Comment Letter R17

Lilac Fire 2017 sequential maps showing changes to the Fire Perimeter as well as Evacuation Warning and Order areas on Thursday, December 7, 2017, from 2:00pm through 11:00pm.

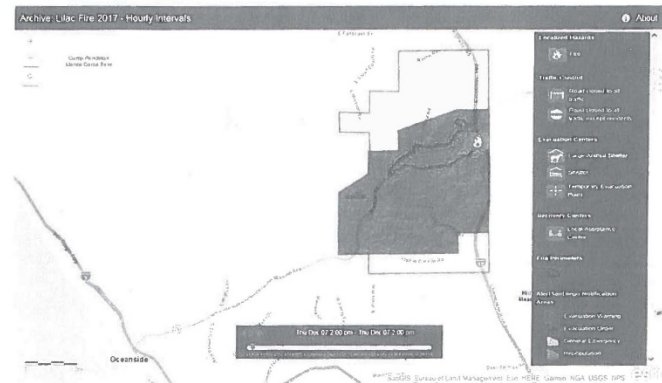
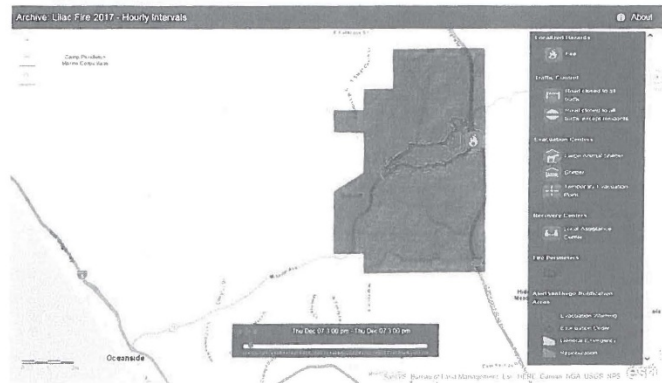
R17-8

COMMENTS	RESPONSES
<p data-bbox="751 224 926 243">Comment Letter RI7</p> <div data-bbox="184 310 940 1328">  </div> <p data-bbox="982 802 1031 821">RI7-8</p>	<p data-bbox="1062 165 1425 193">Response to Comment RI7-8</p> <p data-bbox="1062 201 1990 345">The County acknowledges the provided Lilac Fire After Action Report. This information raises no new issues and is not applicable to fire spread within the Harmony Grove area based on different fire environments, as described in Response to Comment RI7-5, above.</p>
